00393-01725 Version 2

Rattle from the Tailgate Area on Rough Roads or Going over Bumps

(Supersedes 14-076, dated December 4, 2014, to revise the information highlighted in yellow.)

Year	Model	Trim	VIN Range
2011–15	Odyssey	All with power tailgate	ALL

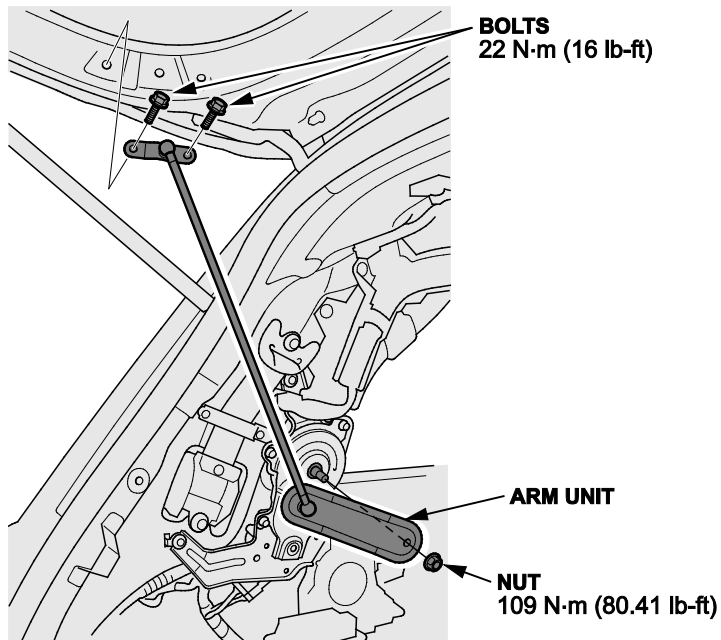
The illustration and torque setting has been changed in step 13.

13. Install the new power tailgate arm and torque the bolts to **22 N·m (16 lb-ft)** and the nut to **109 N·m (80.41 lb-ft)**.
